# DAB-4c/DAB-4s Release Notes

Version 1.35.1  
05.12.2025

System Settings  
Time / Clock

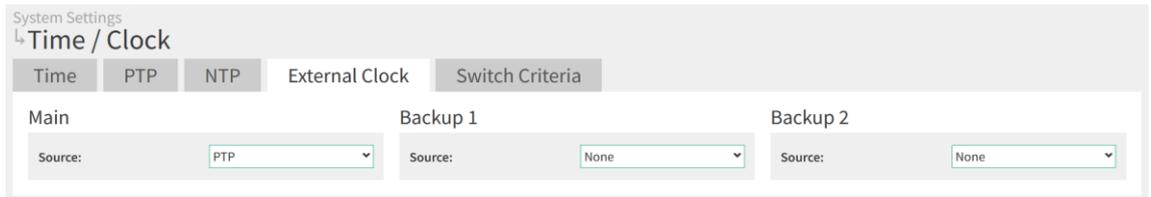
- The PTP functionality did get a complete revision, as it was not working reliably. In the course of these changes we did also revise the way to configure everything related to time and clock handling including NTP and external clock. Before this revision several menu options were involved in the configuration. The selection of interfaces, on which PTP should be enabled was done via the “Network Settings / Services” menu. The PTP configuration itself (e. g. domain number and delay mechanism) was done via the “Settings / External Clock” menu (but only allowing to use the same configuration for all interfaces enabled for PTP). NTP configuration was done via “Network Settings / NTP”, time configuration (time zone) via “System Settings / Time. All these configuration options are now consolidated into a single place – the menu “System Settings / Time/Clock”:

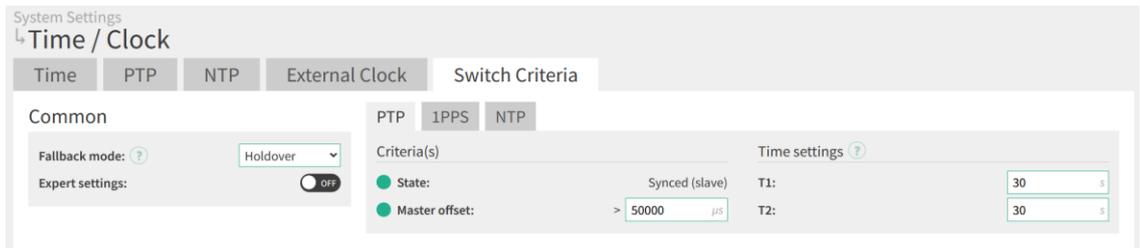
- You still have to configure via the “External Clock” tab (which corresponds to the former “Settings / External Clock” menu), if and which external clock source (PTP, NTP, 10MHz) should be used for the clock synchronization.

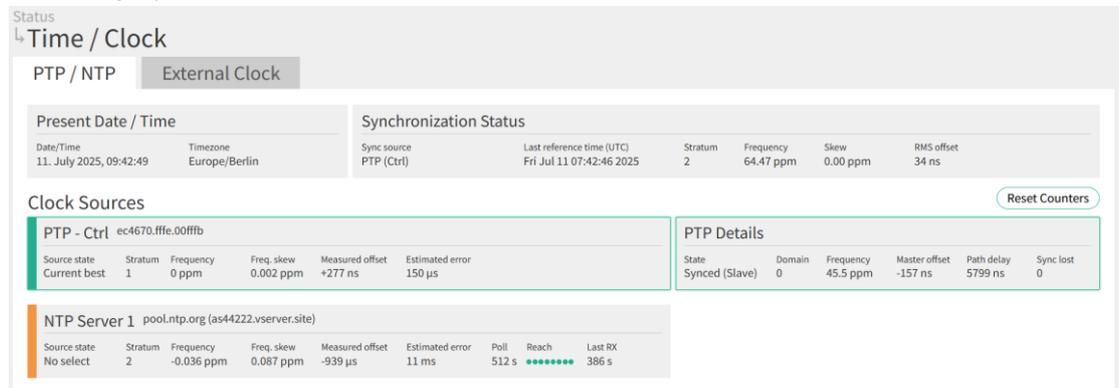
If a backup for the external clock is configured (e. g. NTP), the switch criteria are now configured via the “Switch Criteria” tab of the “Time / Clock” menu.

There’s also a new “Fallback mode” which allows you to control the behavior if all configured external clock sources do fail. In “Holdover” mode (the new default) the device will keep the last external clock (no longer regulated) and will not switch to the internal clock, which would always result in a glitch.

Generate settings file: .xml

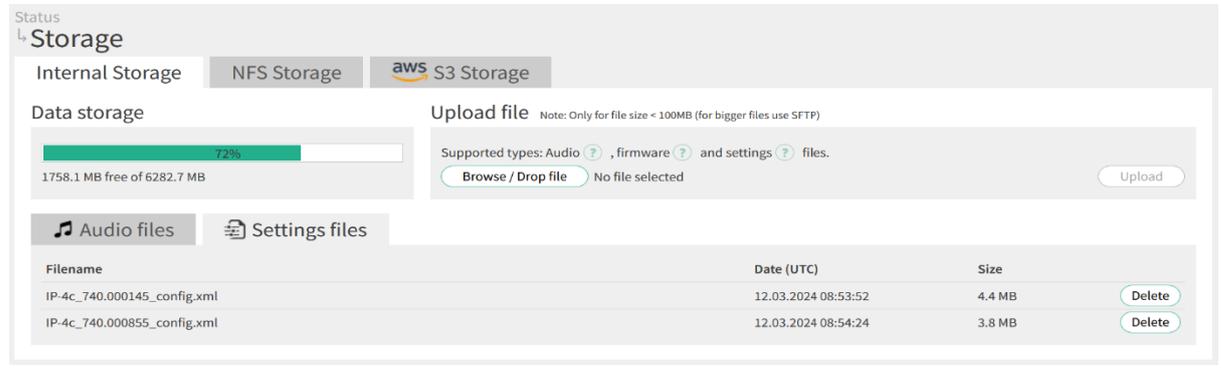
- Added event log entries when loading a settings file or loading factory settings
- When generating a settings file on the Global page you can now not just only download the file, but also save it to the internal storage. You can also directly change the name of the settings file.

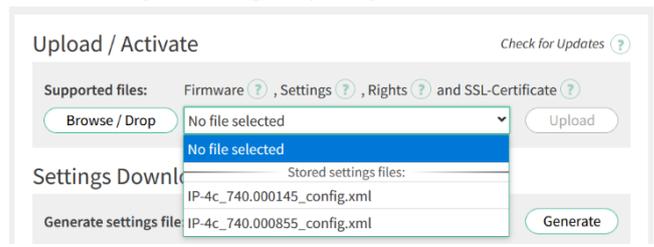
- Settings files can also be uploaded via the Storage page
